Permit: EH-13-012

Re: Addendum #1
Murphy Larsen Ranch Clubhouse
Clark, Colorado
Soilogic Project # 11-4008

MURPHY LARSEN RANCH CLUBHOUSE
CLARK, COLORADO

Re: Septic System Observation and Testing Services and As-Built Diagram
Murphy Larsen Ranch Clubhouse
Clark, Colorado
Soilogic Project # 13-5002

PROPOSED SEPTIC LAYOUT DIAGRAM

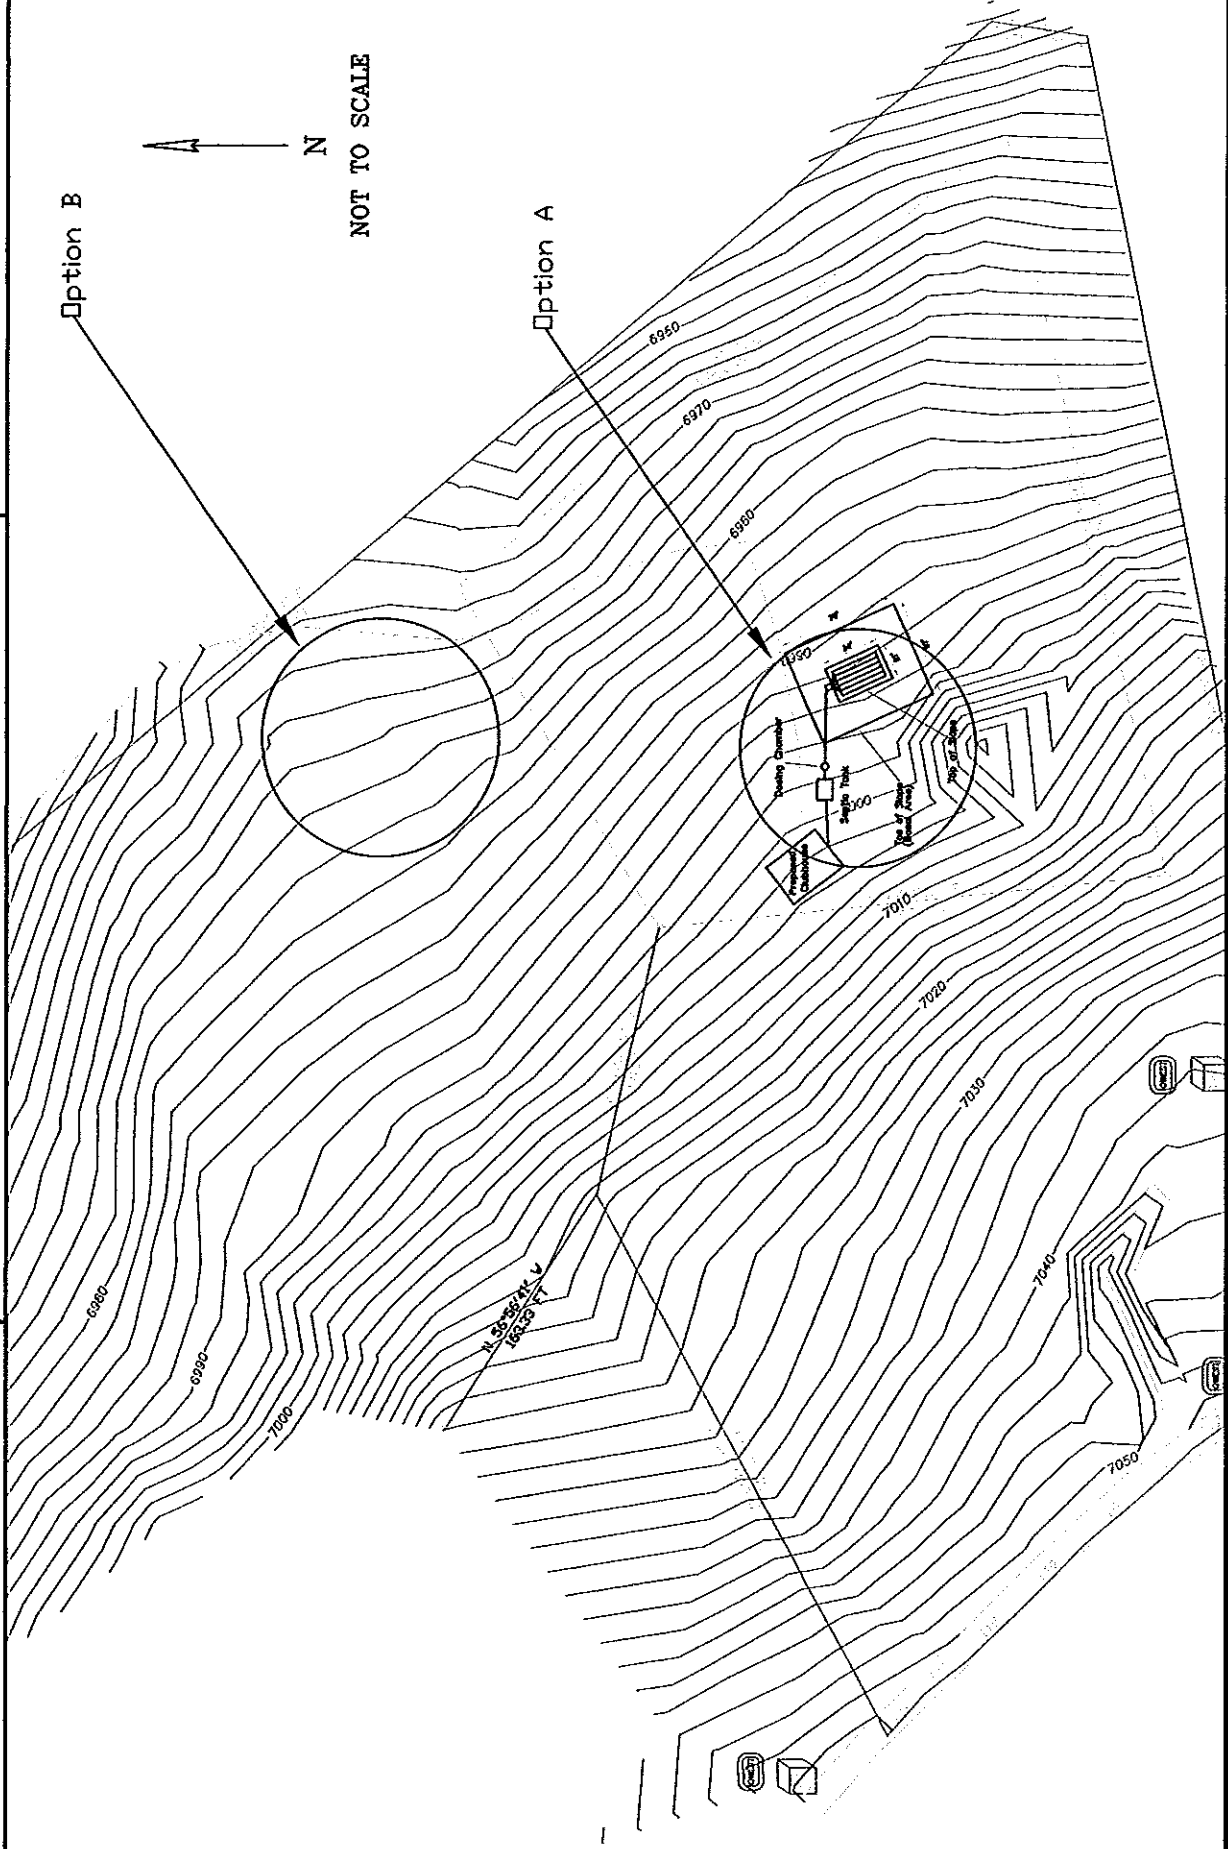
- questions
- ? • Inspection ports in Bed 576
 - Inspection schedule Perc
 - Perc Rate or (TAR) (which is used)
 - Design Q - how arrived at?
 - Normally we see smaller Dia. pipe suspended in chambers 1.5" - 2" and No "D" box

- The plan does not show the type of the septic tank.
- No information is provide on the dosing chamber, or the equipment used for dosing.
- A soil percolation rate, or LTAR is not provide, or shown in the sizing calculations.
- Please provide further information on how you determined at your flow calculations.

Concerning the requested supplemental information for the Septic Design completed for the Murphy Larsen Ranch, We recommend inspection ports be installed at the ends of each infiltrator run within the absorption field and at appropriate locations between the residence and septic tank and between the septic tank and the absorption field.

As part of our site observation services, one (1) site visit would be completed after development of the mound to hand auger supplemental percolation test holes and presoak. Soilogic would return to the site after presoaking to verify the percolation rate of the developed soils meets the intent of the design. One (1) additional site visit would be completed to verify septic tank size, the presence of an auto siphon and the size of the field along with positive drainage within the distribution works.

Attached is a summary of design calculations used to size the field. An average percolation rate $t = 30$ minutes /inch was used in design. Based on discussions with the owners representative, an average of four (4) persons per day was estimated to use the facility and used to calculate septic design flow using the quantity and type of fixtures proposed for the clubhouse. We understand a rock and pipe distribution field will be constructed as opposed to graveless soil absorption such that an absorption bed size of 567 sf will be required.

SEPTIC SYSTEM AS-BUILT DIAGRAM

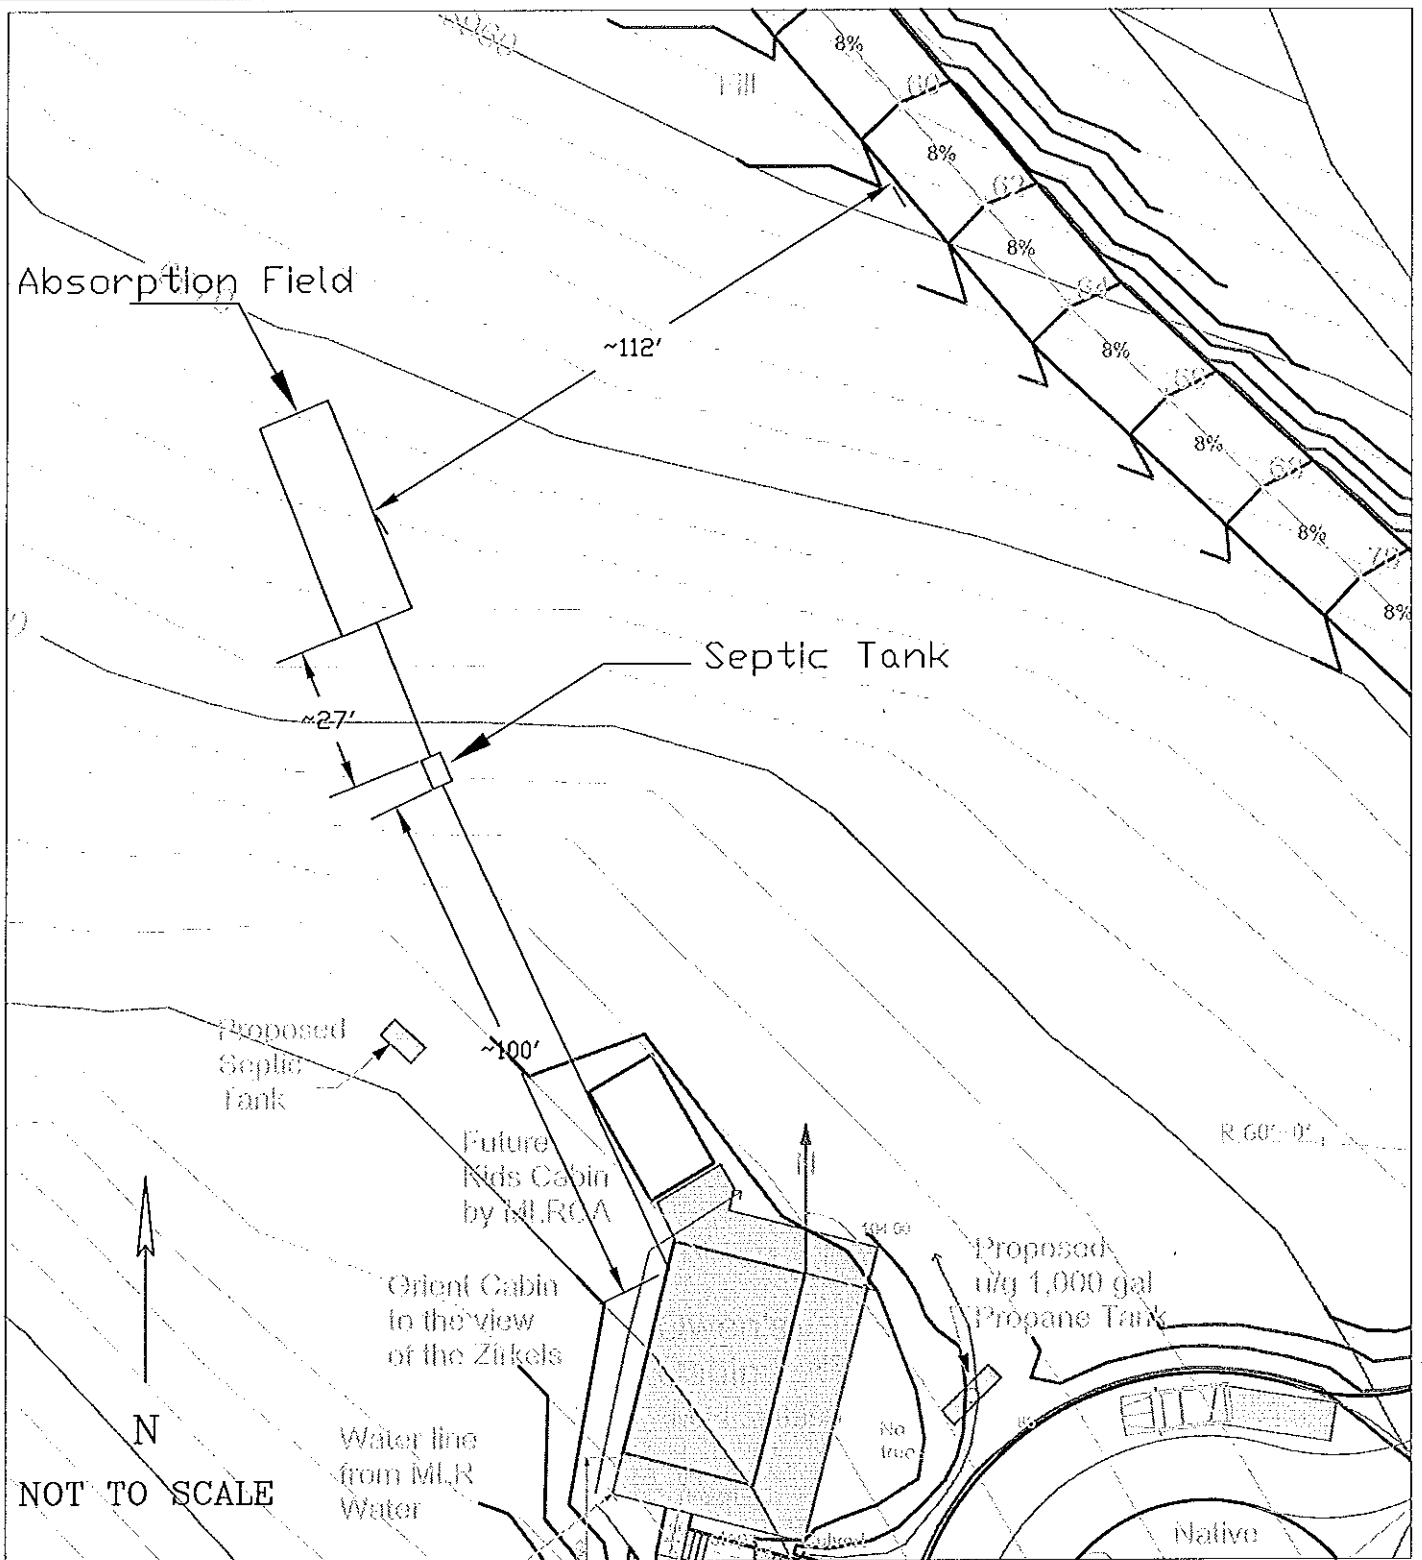
- Routt County ISDS regulations sections 15, D requires that a clean-out be placed at least every 100 feet. The as-build drawing shows the line between the house and the tank to be 100 feet with no clean out. It is also important to note that distances shown on the as-build should be exact. Is 100 feet the exact distance?
- Routt County ISDS regulations, section 6.05.8 require that inspection ports be installed in each trench. The as-build drawing submitted does indicated that inspection ports have been installed.

SEPTIC SYSTEM
AS-BUILT DIAGRAM

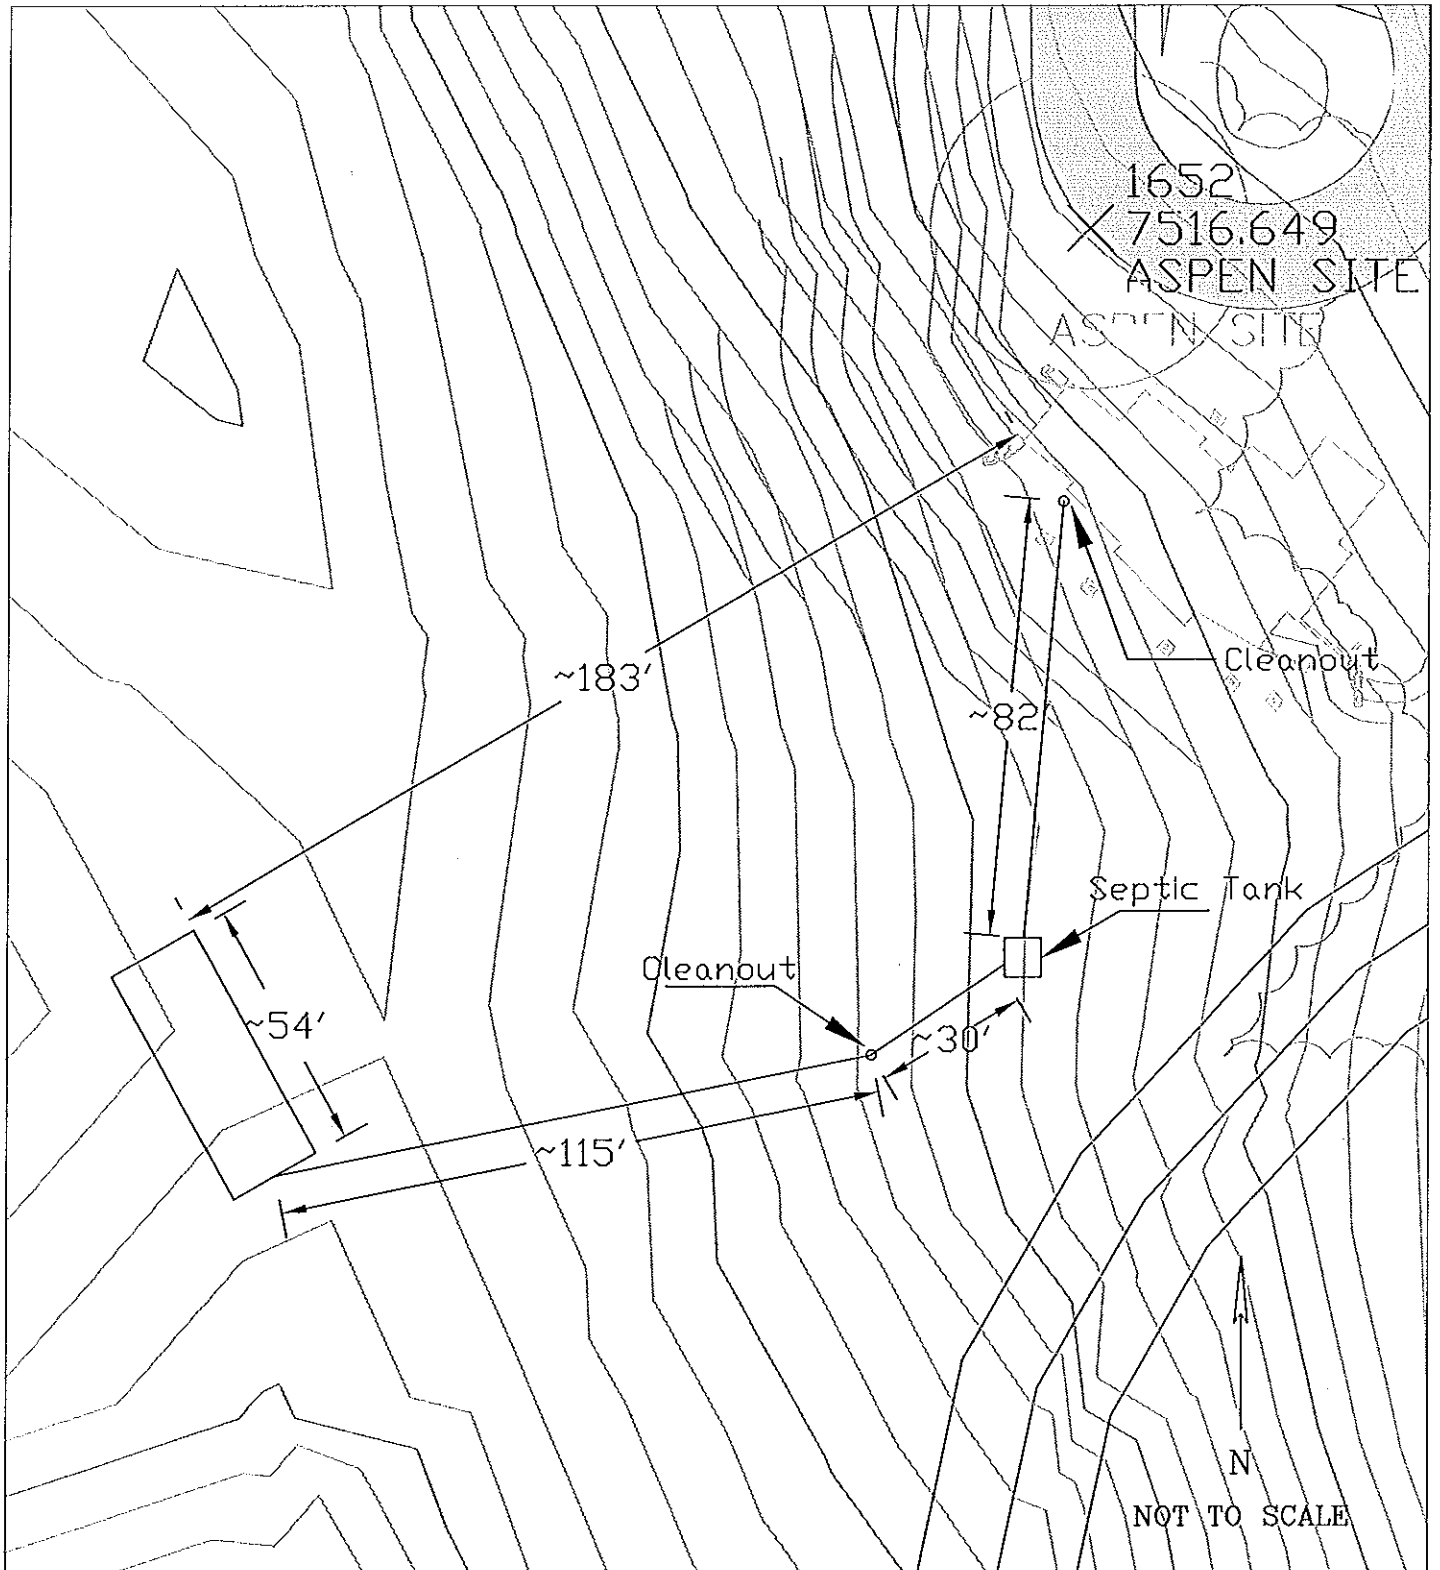
- Routt County ISDS regulations sections 15, D requires that a clean-out be placed at least every 100 feet. The as-build drawing submitted shows the line between the house and the first clean out to be 115 feet.
- The final inspection letter does not indicate that any inspections of the system have been conducted.
- The final inspection letter does not state that this system was constructed in accordance with the design criteria.
